INDEX

"FIXES ARE GREAT IN '98"

INTRODUCTION

Figure 1

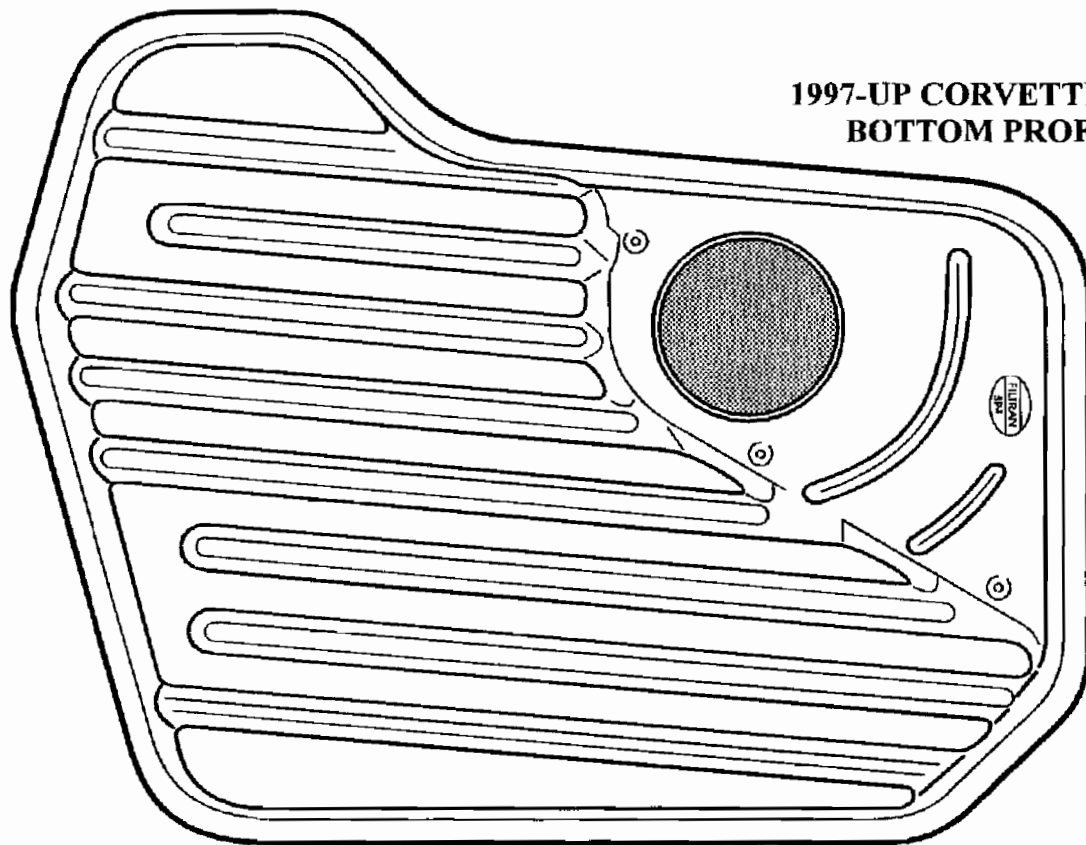
CHANGE: Beginning at the start of production for 1998 model vehicles, there was a new design bottom pan introduced on all "C" Trucks, "K" Trucks and "G" Vans. All other models use the regular pan, except the Corvette. The Corvette has its own pan since 1997. The new design bottom pan is approximately 17mm deeper and requires a new design filter.

- (1) **BOTTOM PAN** - New design is approximately 17mm deeper than the regular pan, and all three bottom pans used in 1998 models are illustrated in Figure 3 for identification purposes.
- (2) **BOTTOM PAN FILTER** - There are now three different filters for the 1998 model year. The bottom profile of the filters are all the same as shown in Figure 1. The side profiles however are different as the "Deep" pan requires the filter with the longer neck, the "Regular" pan requires the filter with the shorter neck, and the 97-up Corvette requires the filter with the added extension on the bottom. Refer to Figure 2.

Bottom pan filters must be used with the correct design level bottom pans and must be used on the models that they were intended for, as shown in Figures 1, 2, and 3.

Figure 2

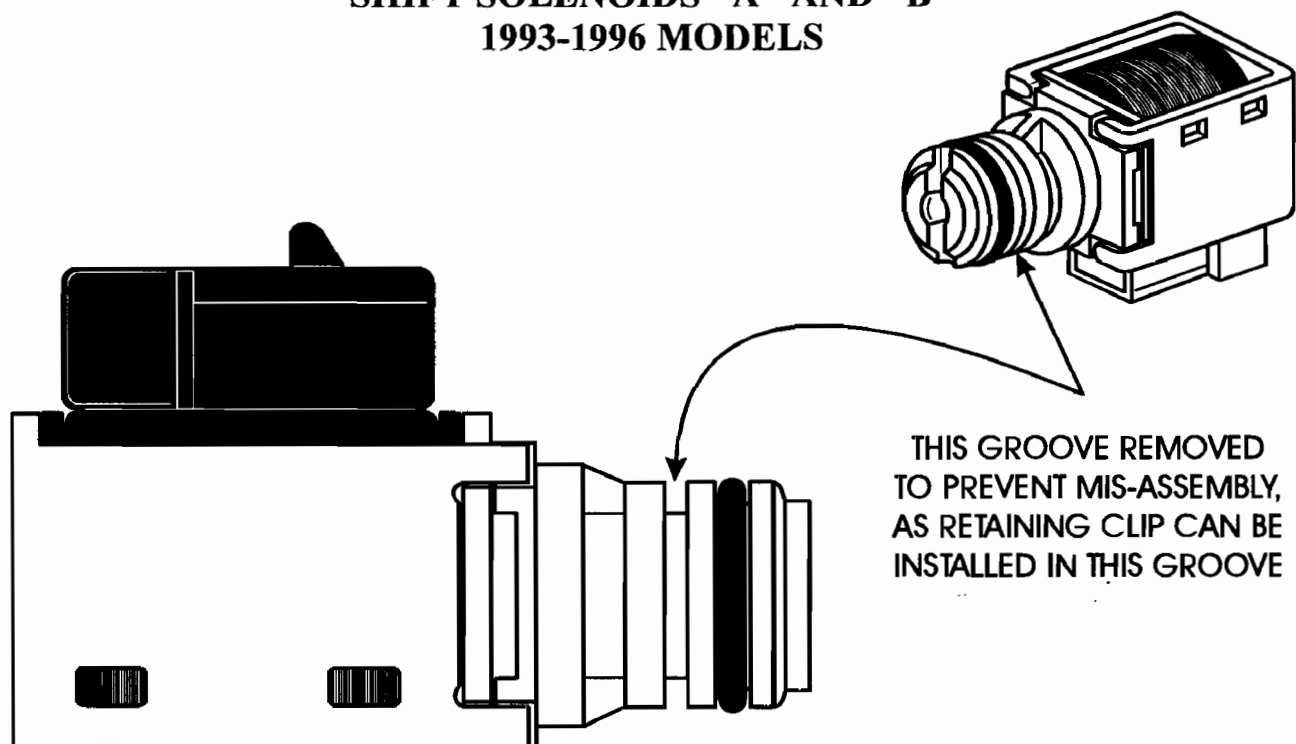
- (2) SHIFT SOLENOIDS "A" AND "B" - One groove has been removed from the stem of the Shift Solenoids to prevent mis-assembly concerns, as the retaining clip can be installed in the previous design solenoids, which means the solenoid is not all the way into it's bore. Refer to Figure 2.

Figure 3

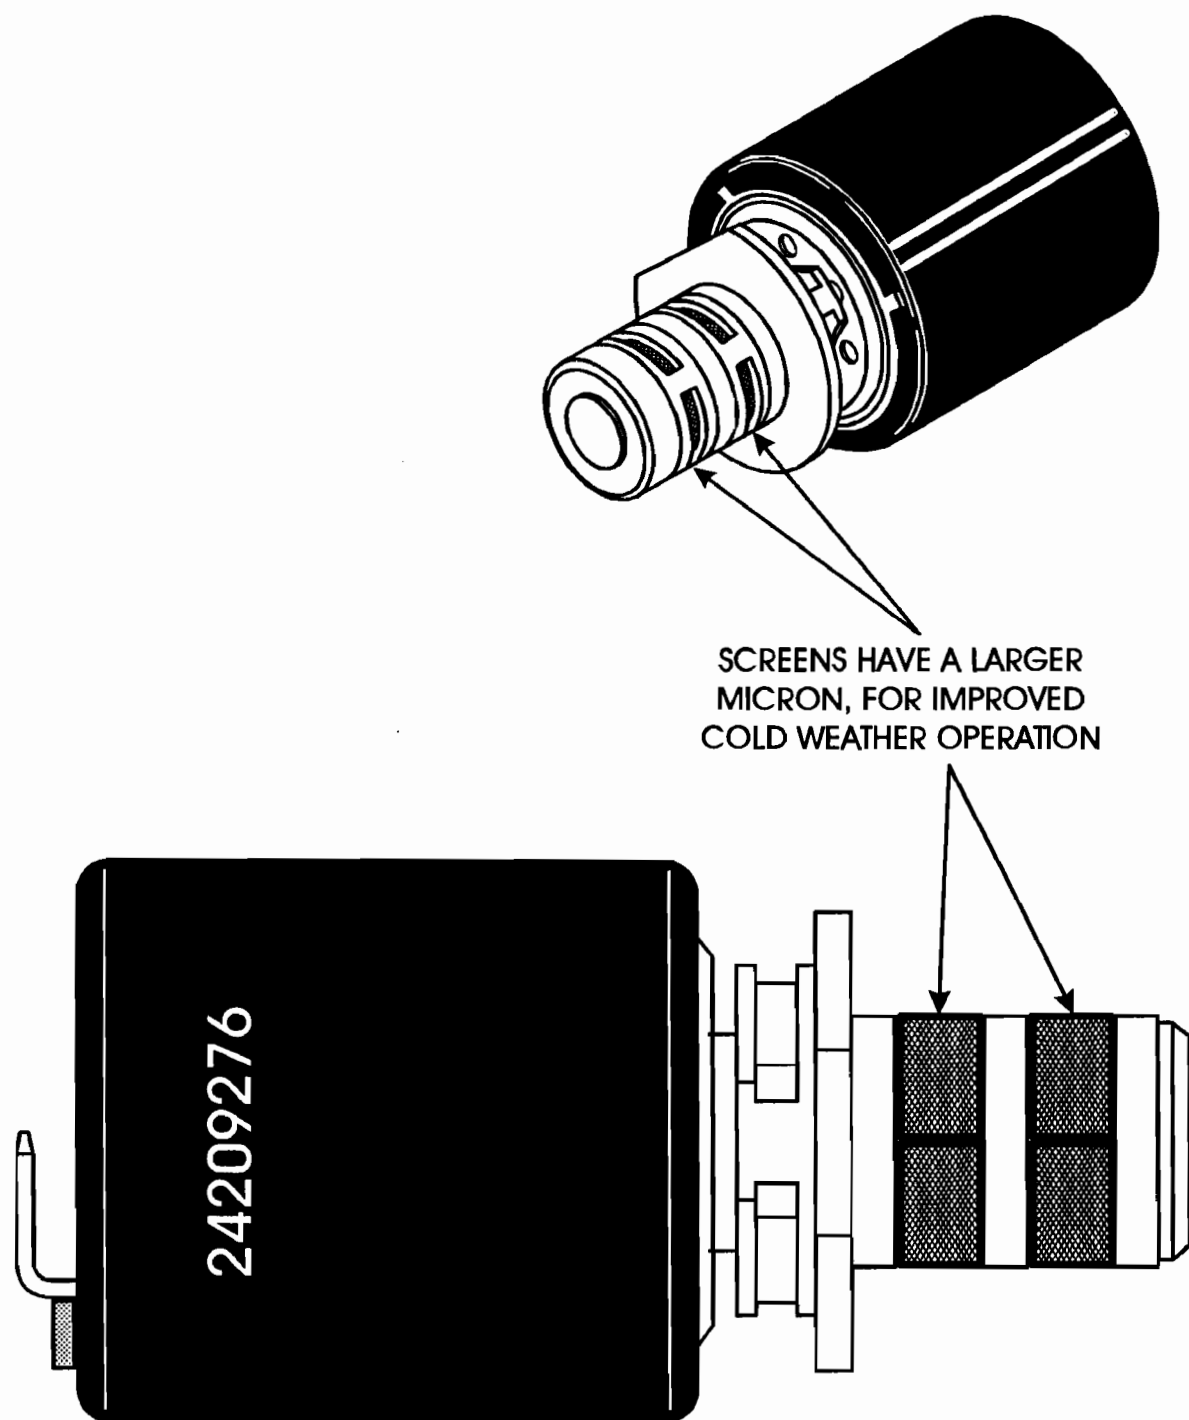
- (3) PRESSURE CONTROL SOLENOID - New design has larger micron screens in the solenoid to greatly improve cold weather operation. This will allow the colder oil through the screens easier. Refer to Figure 3.

Figure 1

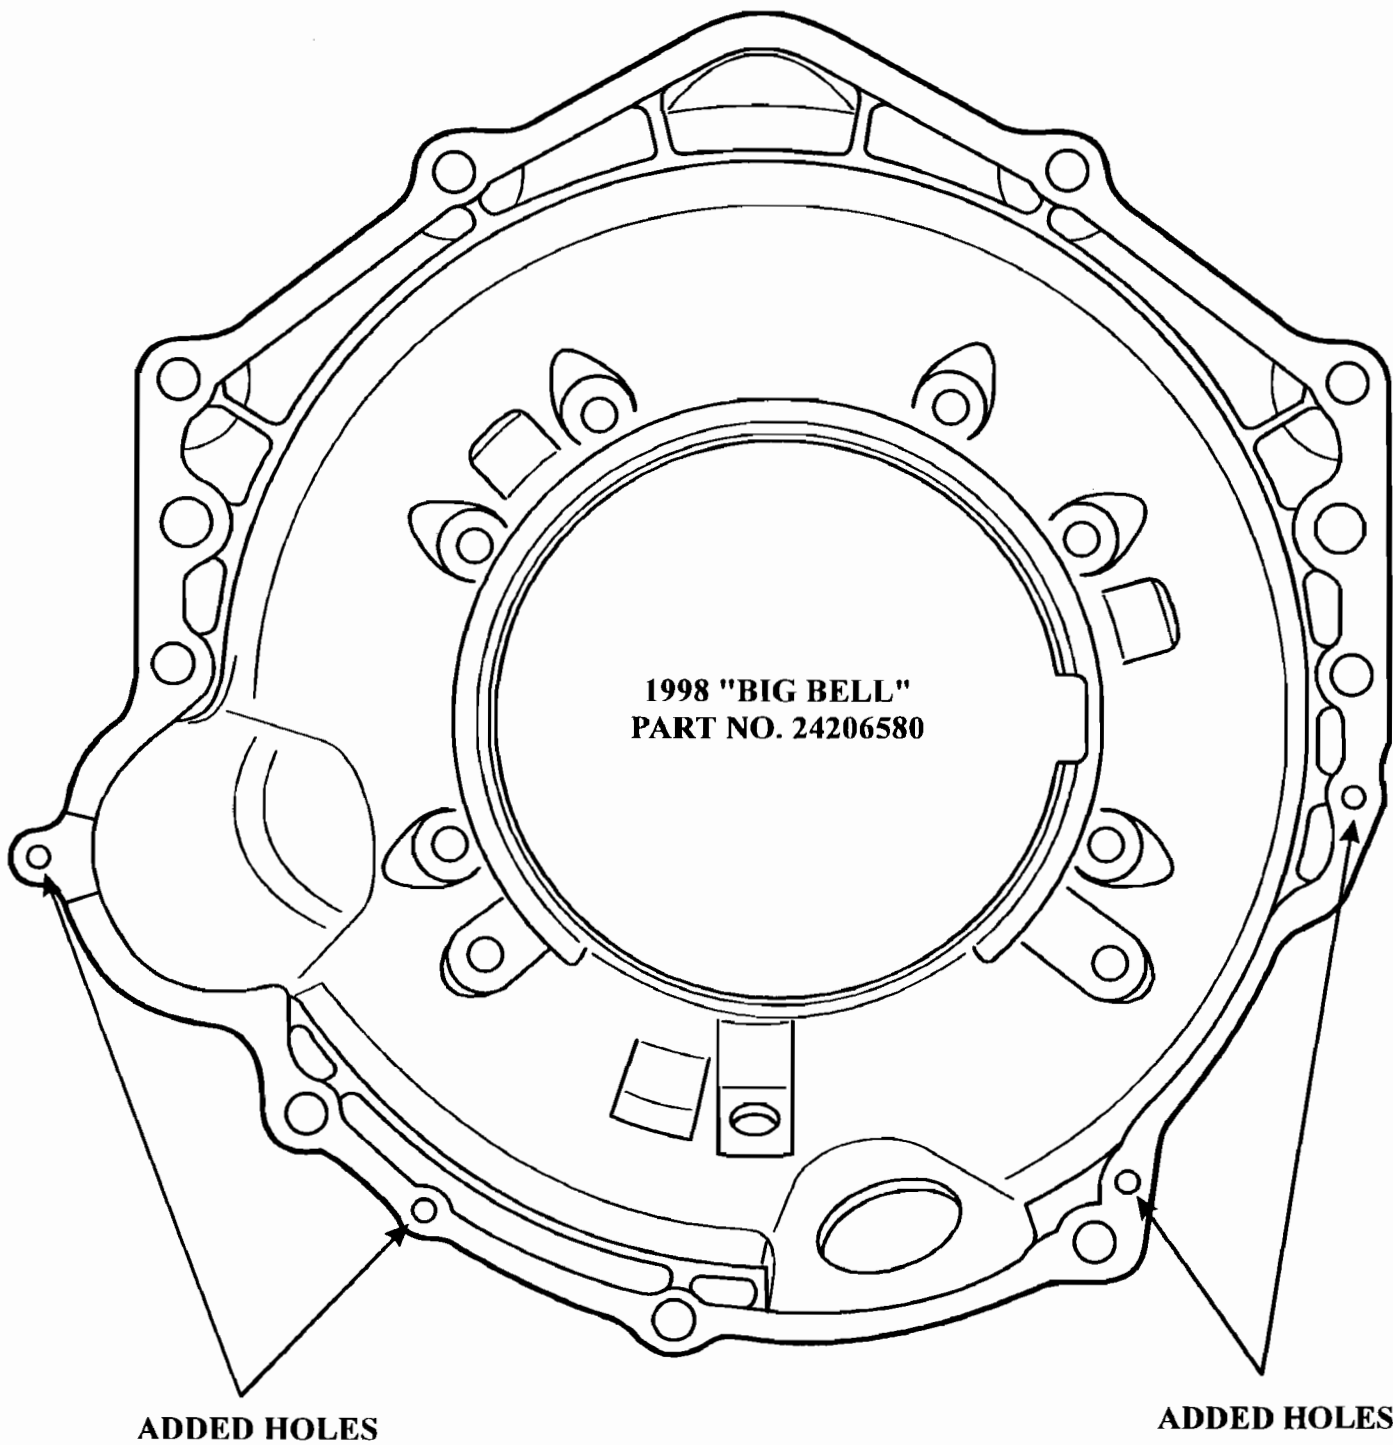
The Bellhousing shown in Figure 1, is approximately 1/4" deeper than the previous "Big Bell" and is designed to accommodate a new 300mm converter that is used in the 1998 Firebird. The best identification is the added bolt hole at the top of the bellhousing. This style bellhousing and the 300mm converter also require a new design turbine shaft and stator shaft that are also about 1/4" longer.

ADDED BOLT HOLE AND
IS APPROX. 1/4" DEEPER

This style bellhousing and the 300mm torque converter also require a new design turbine shaft and stator shaft that are approximately 1/4" longer than other models.

Figure 2

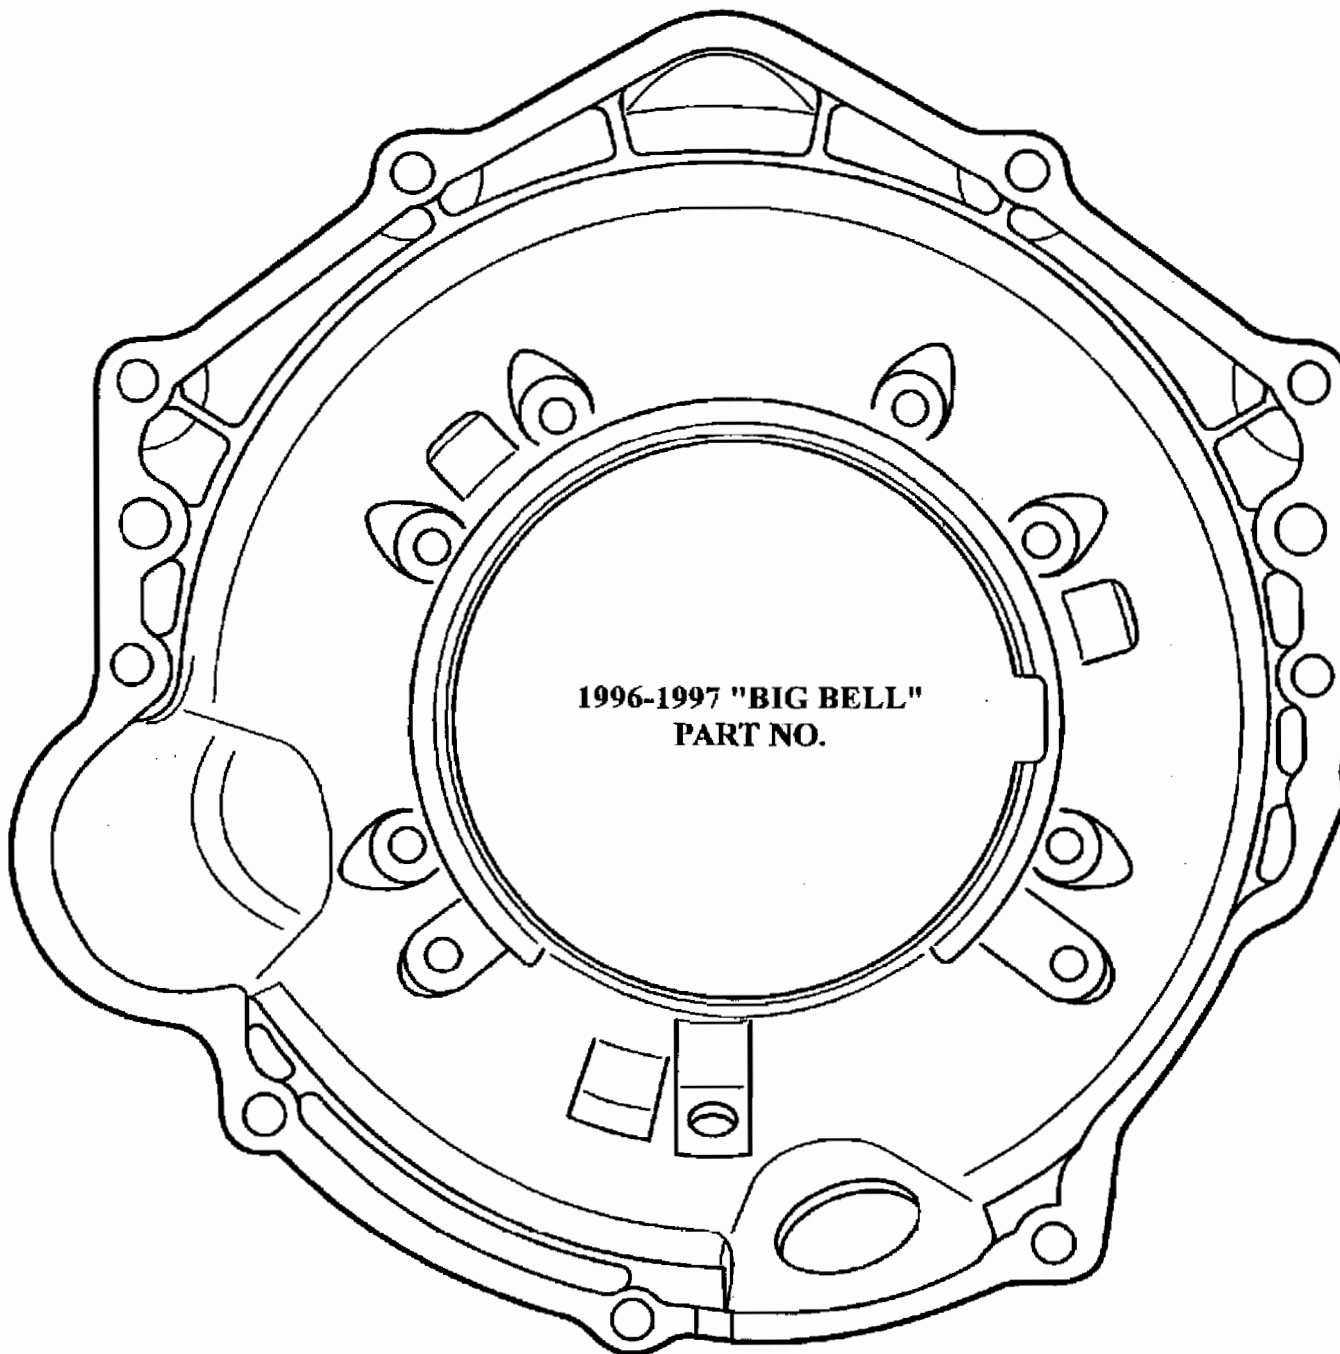
The Bellhousing shown in Figure 2, has four added holes for an added dust shield, and can be compared with the previous model "Big Bell" that is shown in Figure 3.

Figure 3

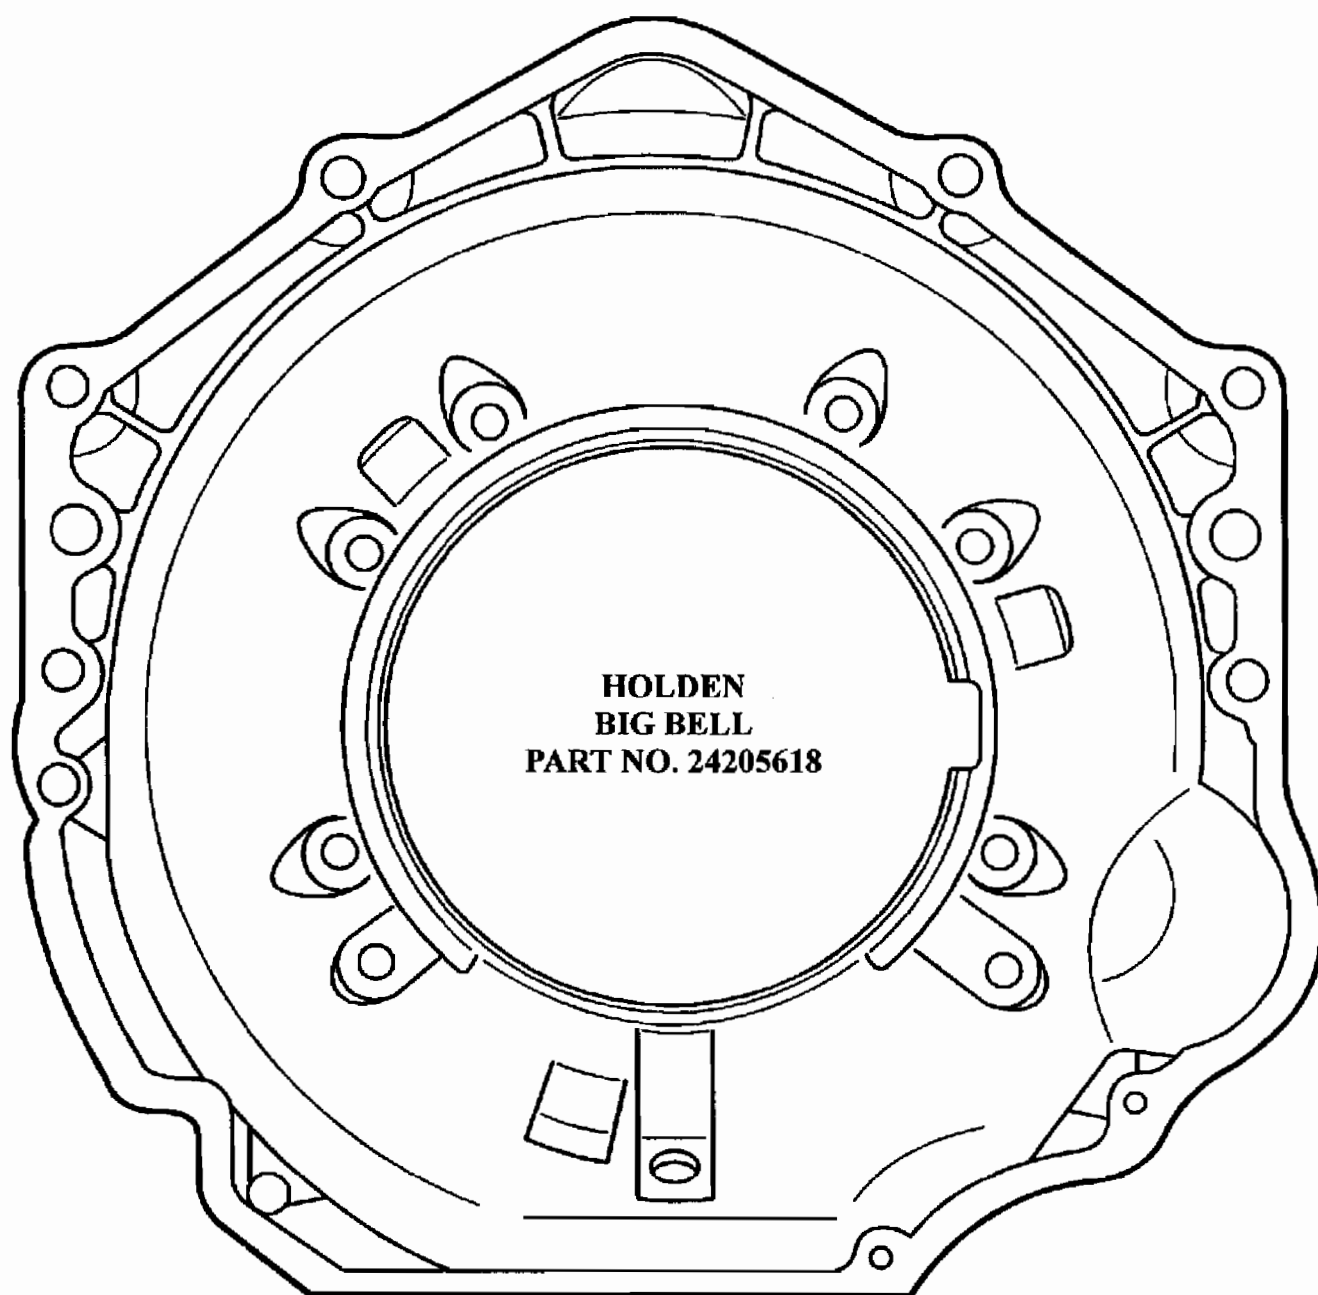
The Bellhousing shown in Figure 3, is the previous design "Big Bell" and included in this bulletin for comparison with the 1998 design changes.

Figure 6

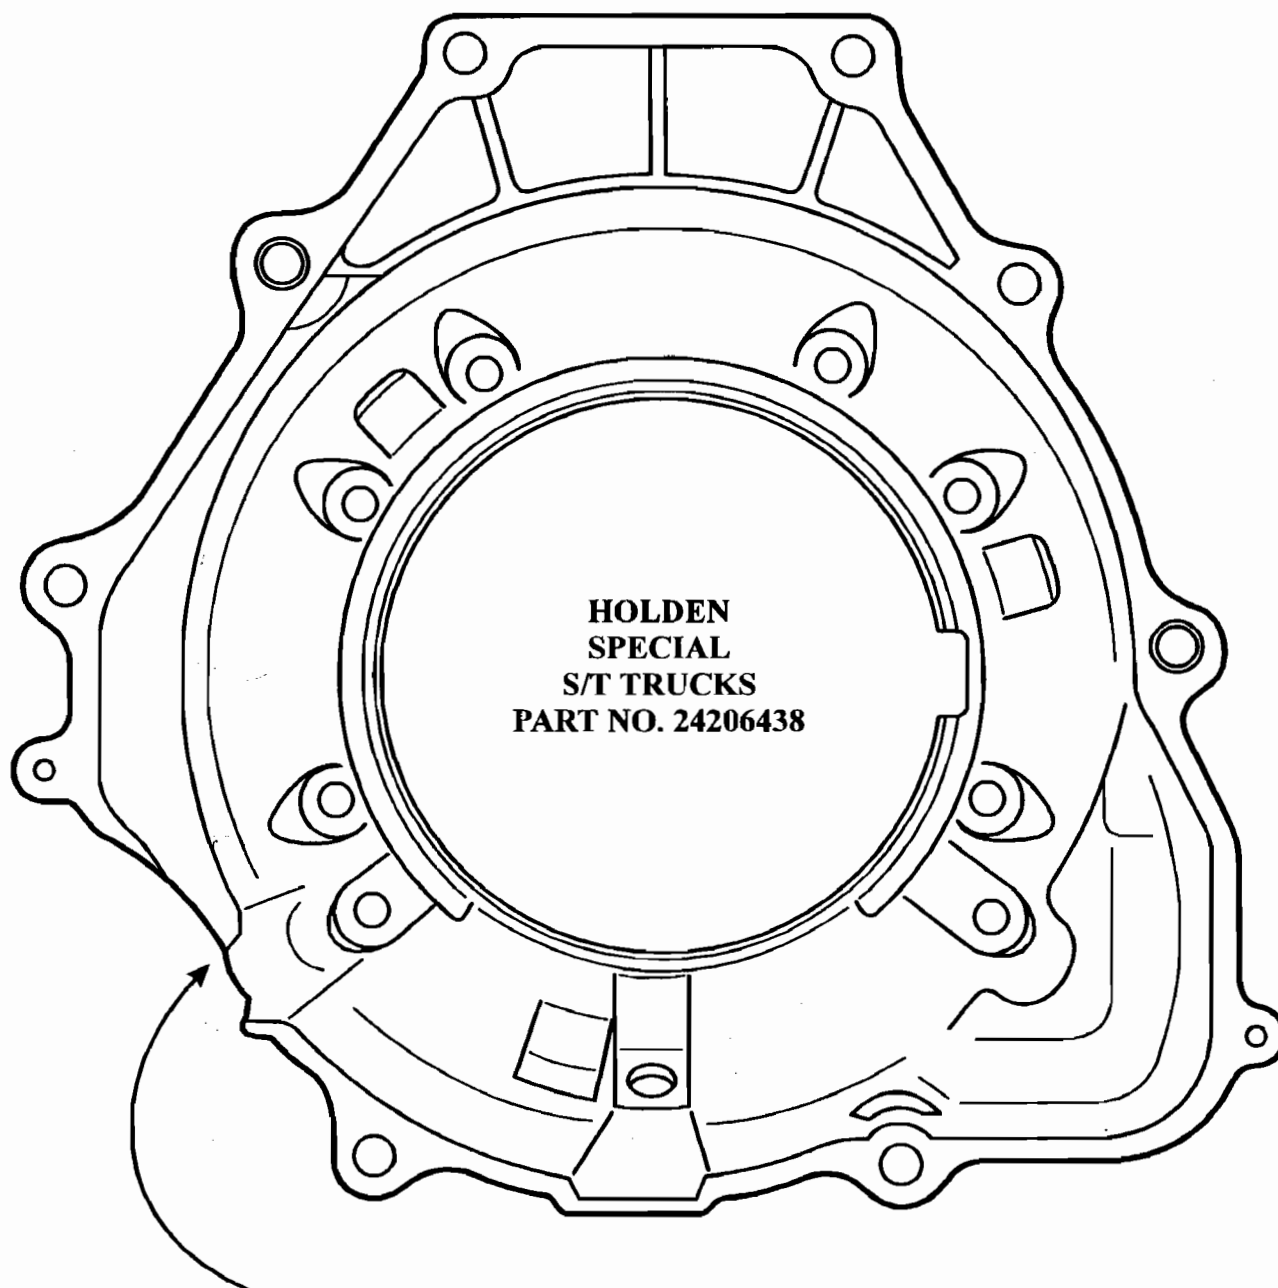
The Bellhousing shown in Figure 6, is the Holden "Special" S/T Truck bell that is export only and shipped mainly to Australia. This bell has part of the housing cast out as compared to the Regular S/T Truck bell that is shown in Figure 7.

**SECTION CAST OUT
OF BELLHOUSING**
